Re: Impact Area Groundwater Study Program
USEPA Region I Administrative Orders SDWA 1-97-1019 & 1-2000-0014
Final J-2 Range Eastern and J-2 Range Northern Interim Environmental Monitoring
report, August 2010 through July 2011, dated July 2012

**J-2 Range Eastern
Interim Environmental Monitoring Report
August 2010 through July 2011**

**J-2 Range Northern
Interim Environmental Monitoring Report
August 2010 through July 2011**

**Camp Edwards
Massachusetts Military Reservation
Cape Cod, Massachusetts**

J-2 Range Eastern Plume Perchlorate
Model-Predicted and Observed Outline

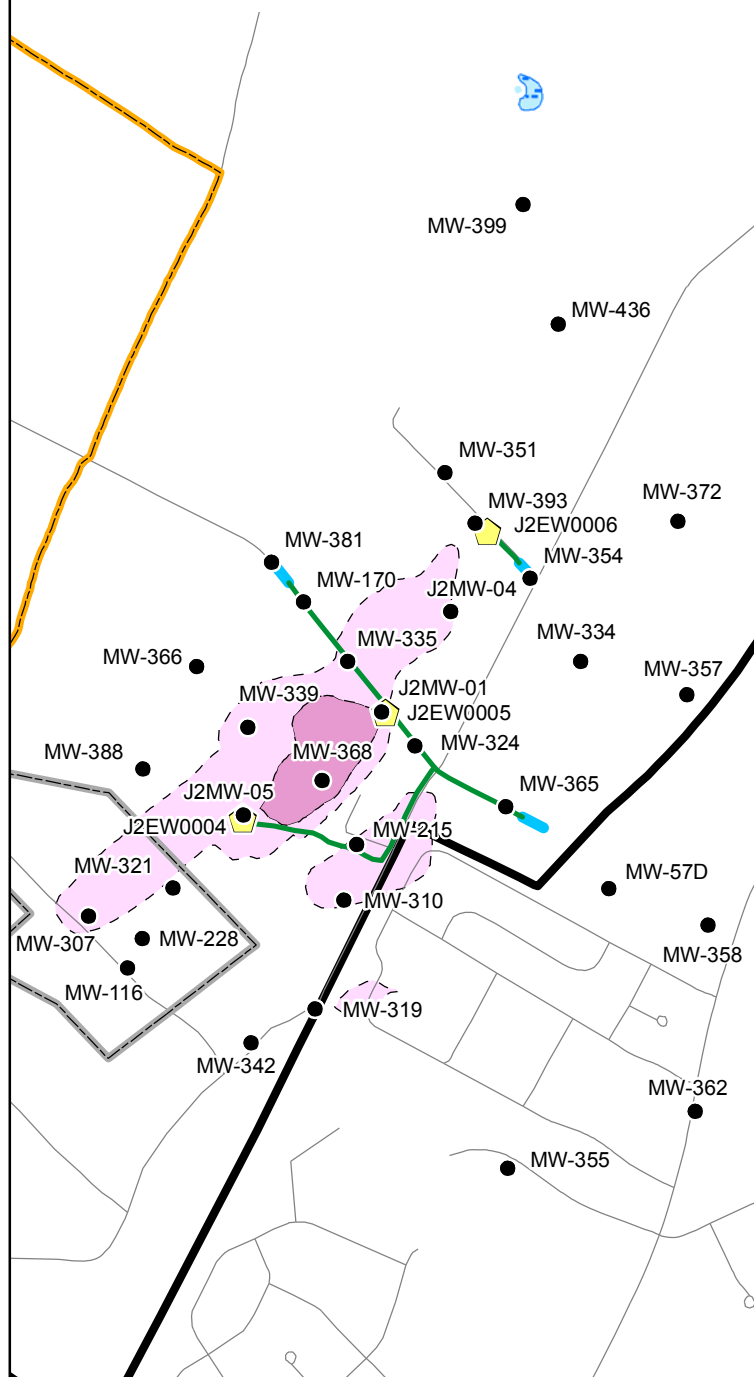
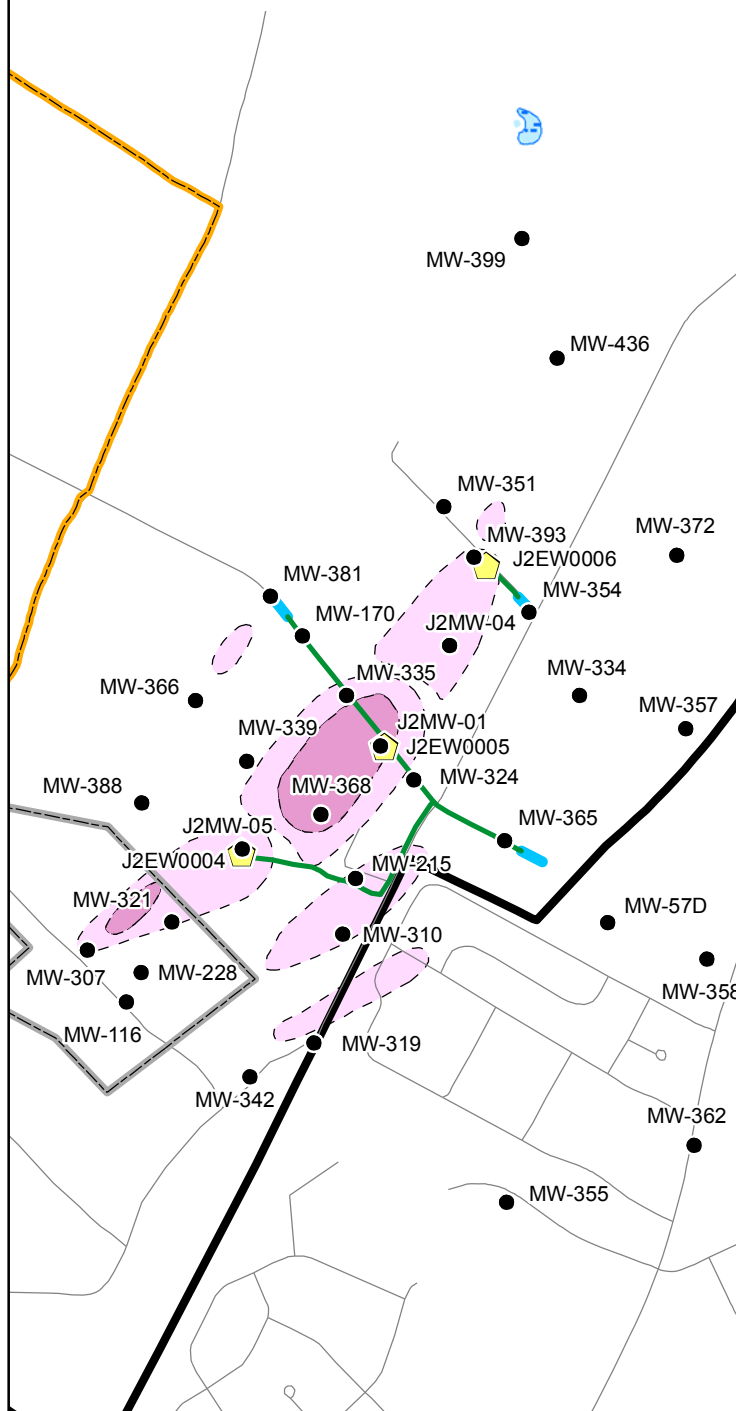
- 15) Pg 6-1, §6.1 - A comparison of model predicted and perchlorate concentration observed during the winter 2011 monitoring event is presented in Figure 6-1. A similar comparison of model predicted and RDX concentrations is provided in Figure 6-2. However, due to the rather broad concentration ranges used in these figures, particularly for perchlorate, it is very difficult to compare the actual and predicted contaminant concentration values based on the information presented in these figures. Moreover, the concentration contours (outlines) presented in the depiction of observed conditions appears to be based on projected historical data as well as current measurements. These figures also are one-dimensional and do not depict the predicted and observed vertical distribution of contaminants.

- 37) Figure 6-1 - There are significant differences between the model-predicted conditions and the observed conditions depicted in this figure. Please edit this report, perhaps in the recommendations section, to discuss why the differences are not enough to justify an upgrade of the model prior to completing the RI/FS.

measurements forward rather than having actual measurements. The annual report is meant to present the measured and predicted plumes to provide for an evaluation of the general shape and magnitude of concentrations and a point-by-point comparison is believed to be outside the scope of an annual report. The contour levels shown in Figures 6-1 and 6-2 are believed to adequately represent the predictive capacity of the model and no changes will be made.

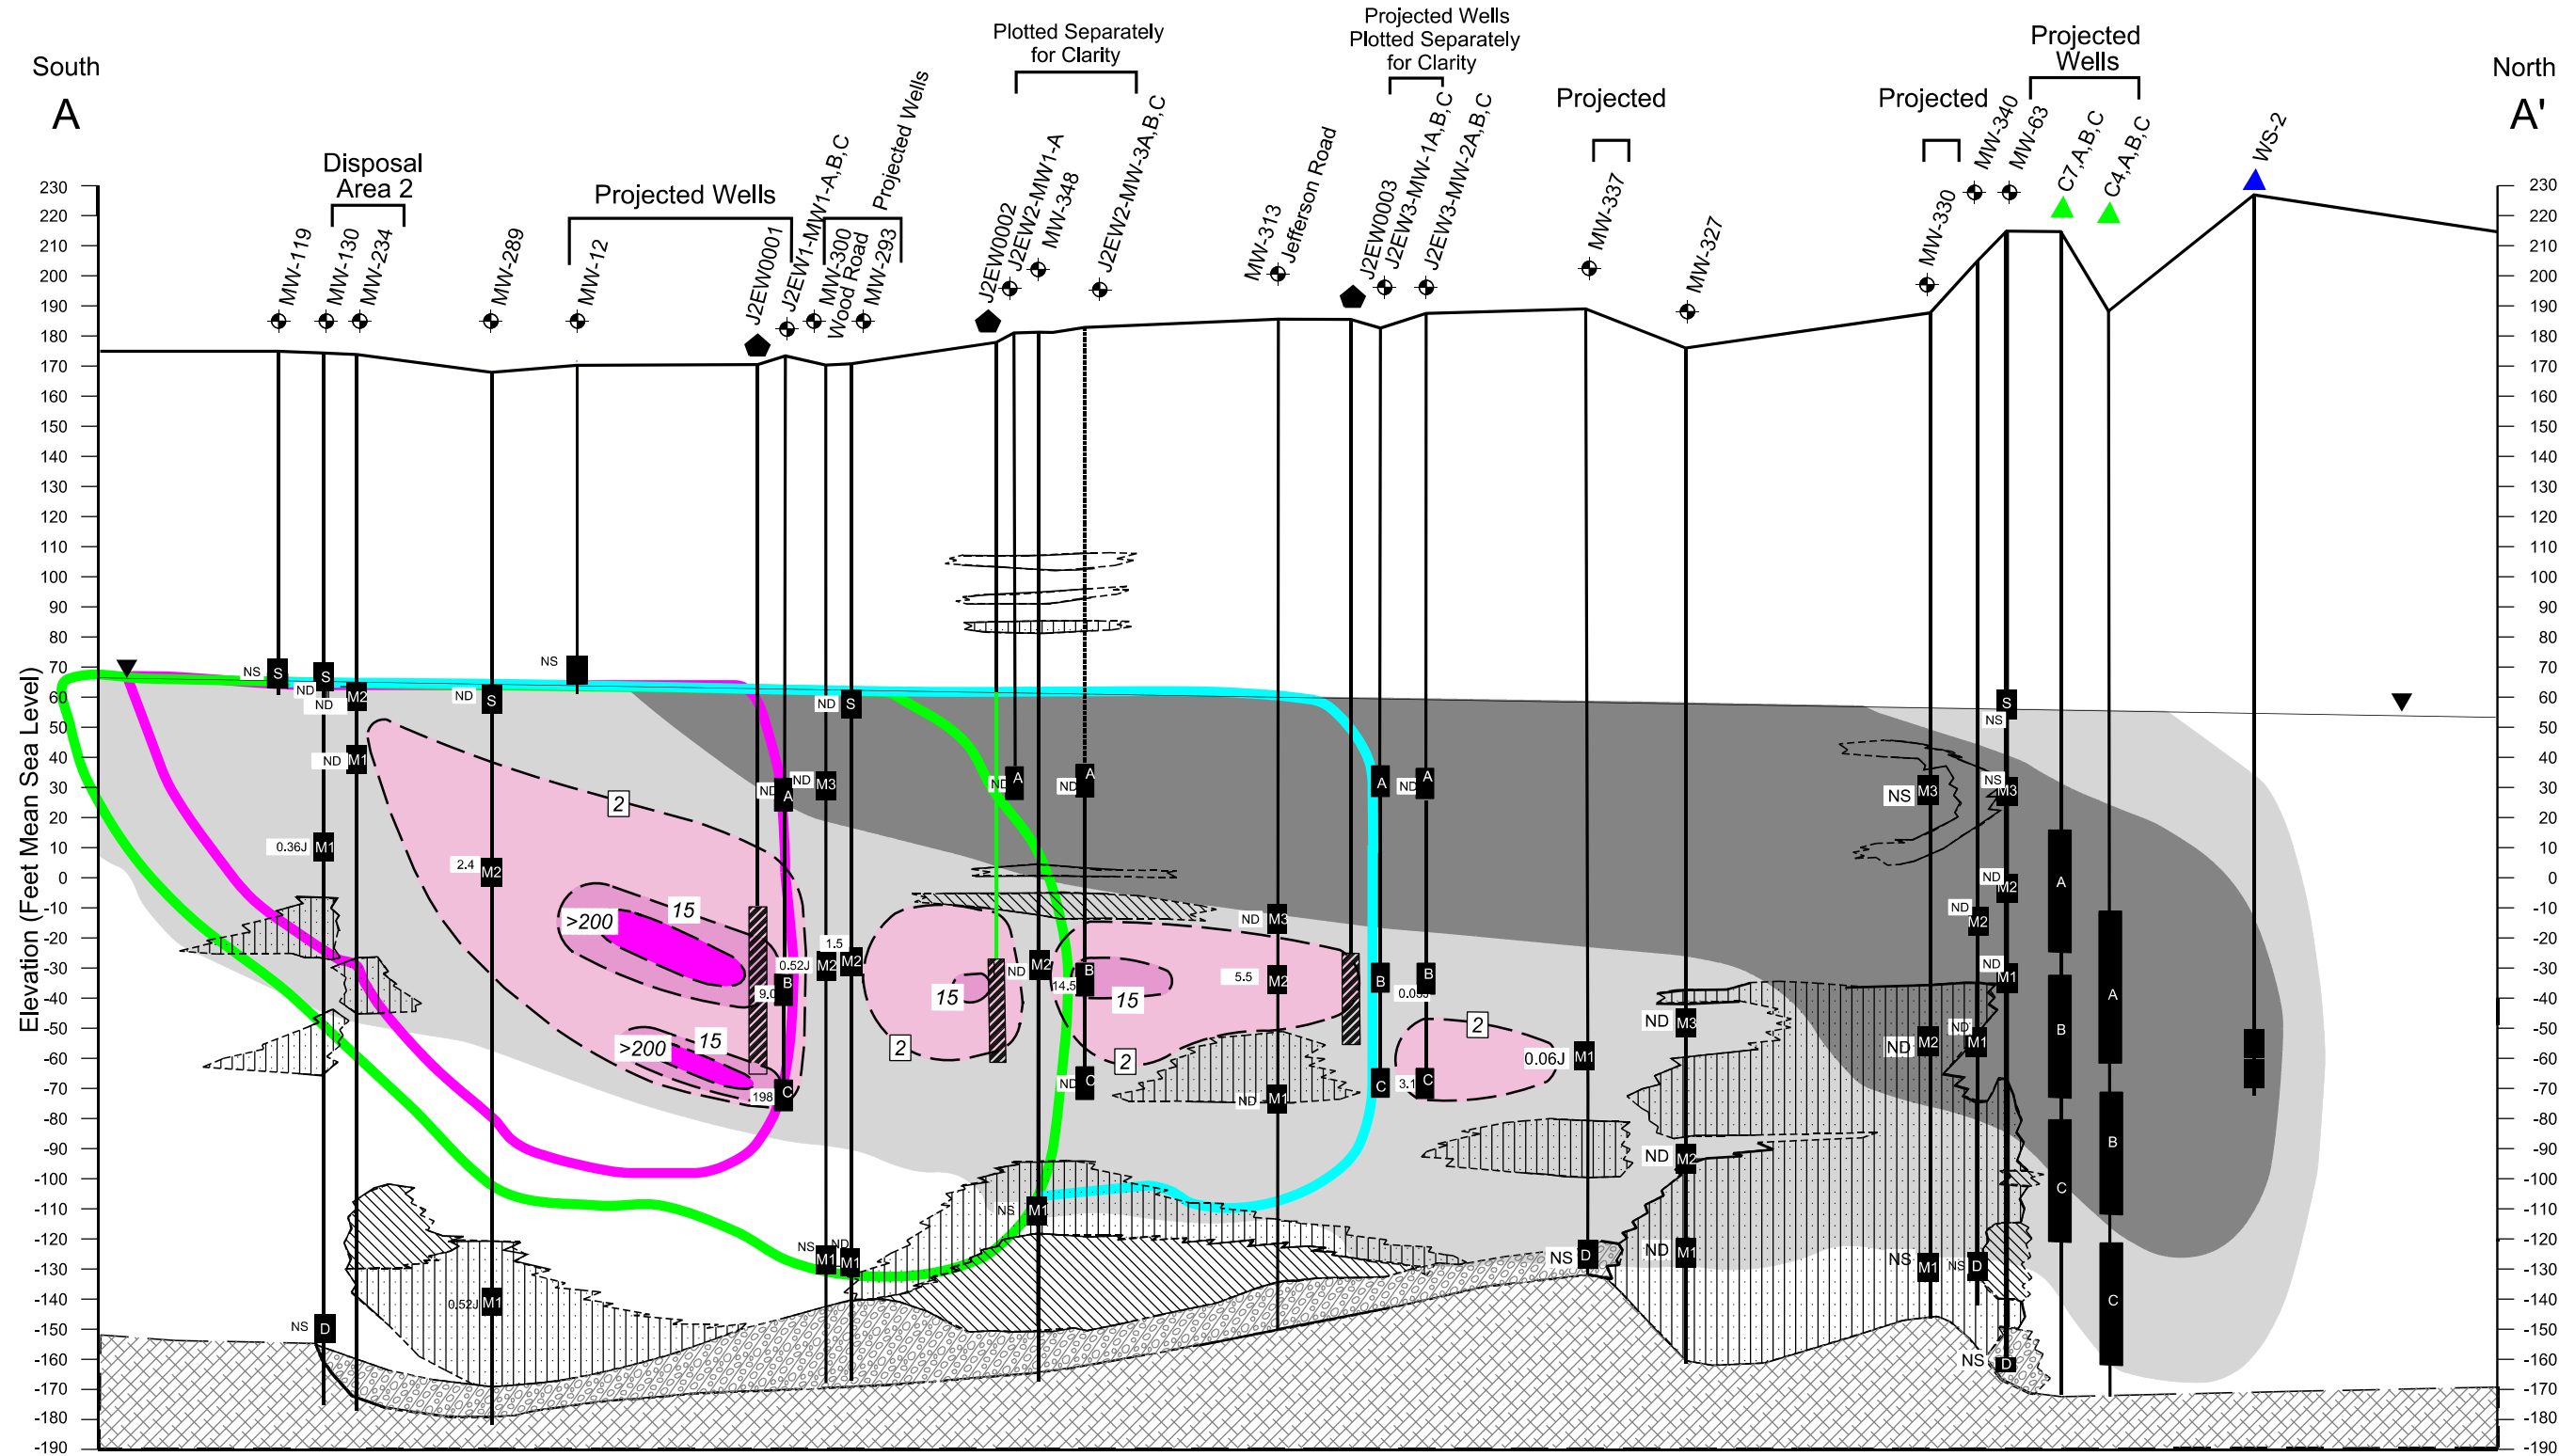
Additional Comment: EPA has received Army's re-submittal of Figure 5-2 dated 1/6/2012 which shows two lobes with concentrations greater than 200 µg/L immediately upgradient of J2EW0001 in response to the detection of perchlorate at 198 µg/L at well screen J2EW1-MW1-C. Please indicate if this second 200 µg/L lobe was added without rekriging the data. Army has proposed further investigation of the plume upgradient of J2EW0001 to better define the plume configuration and concentrations. While two separate lobes are possible as shown in the resubmitted figure, the actual plume configuration can only be determined by the additional field investigation proposed. Although the resubmitted Figure 5-2 shows 2010 operating conditions; Army has stated that the final Figure 5-2 should be revised to depict 2011 operating conditions.

Response: This was not discussed because it is evident in Figure 5-2 that the 2-200 µg/L perchlorate concentrations have largely migrated through the J2EW0002 capture zone and are currently being captured. The sentence "Perchlorate concentrations are not expected to increase at well J2EW0002 in the future because it is believed that, given the predicted travel times, the highest perchlorate concentrations have already migrated to the extraction well" will be added following the first sentence section header "Central Lobes from Wood Road to J2EW0003" in Section 5.1.1.

6-1

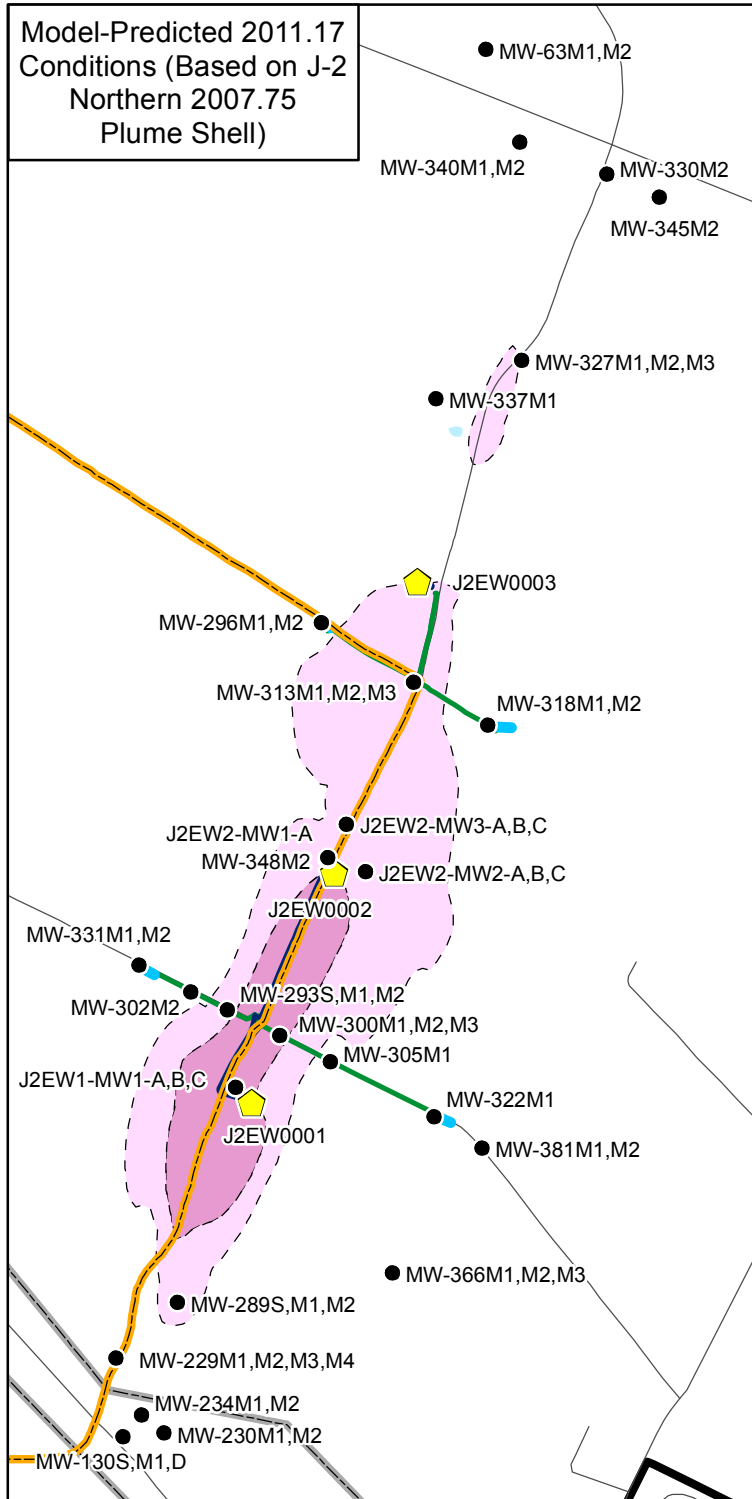
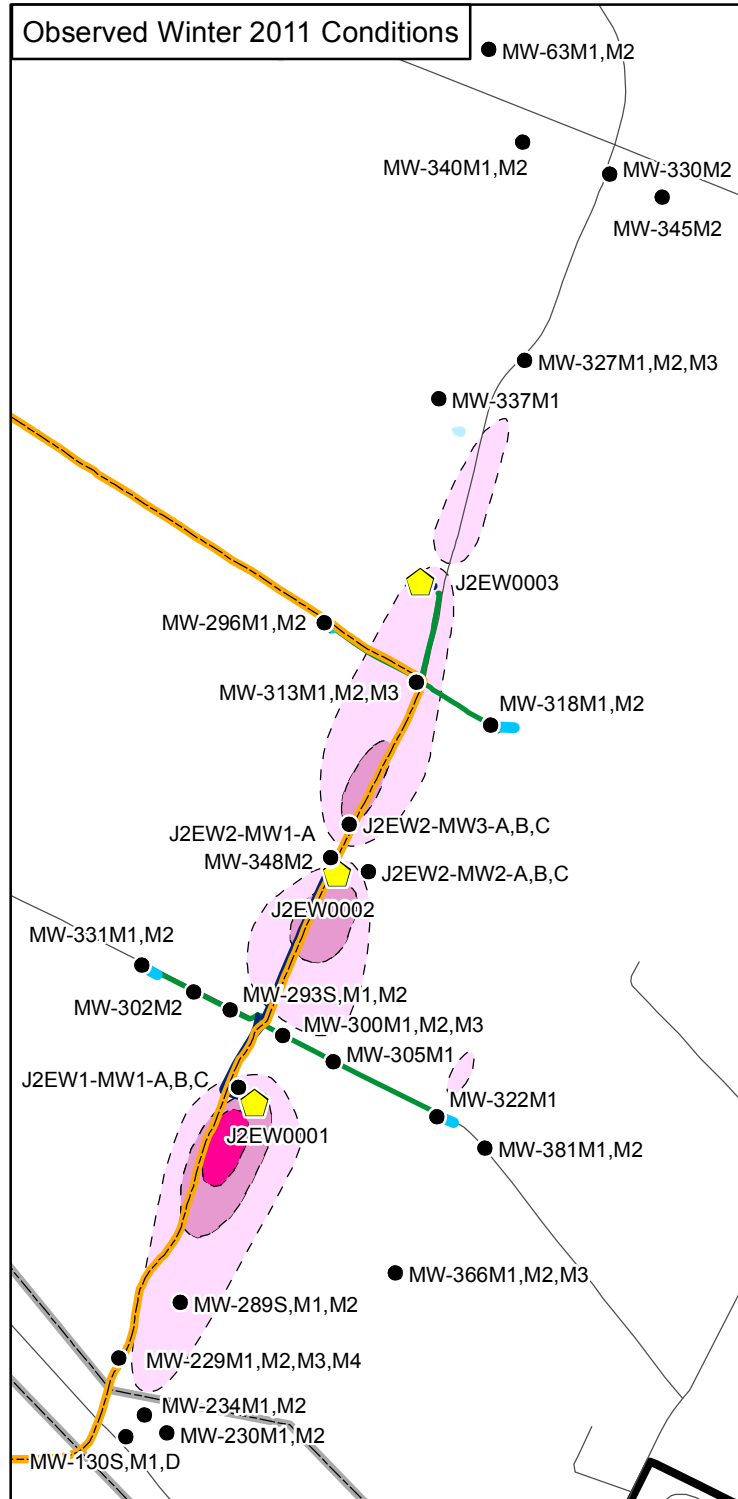
- 22) Pg 6-1, §6.1.1 - Due to the rather broad concentration ranges used in the contouring of perchlorate concentration in Figure 6-1 (2-15 µg/l, 15-200 µg/l, and greater than 200 µg/l), it is very difficult to compare the actual predicted and observed contaminant concentration at each monitoring well. Please provide a table presenting predicted and measured perchlorate concentration values at each monitoring well where contaminant concentrations are measured. Such a table will facilitate the comparison of predicted and observed values and allow for a more thorough evaluation of the reliability of the transport model. Based on concentration values presented in this table, the monitoring report should provide a more detailed assessment of the reliability of the transport model.
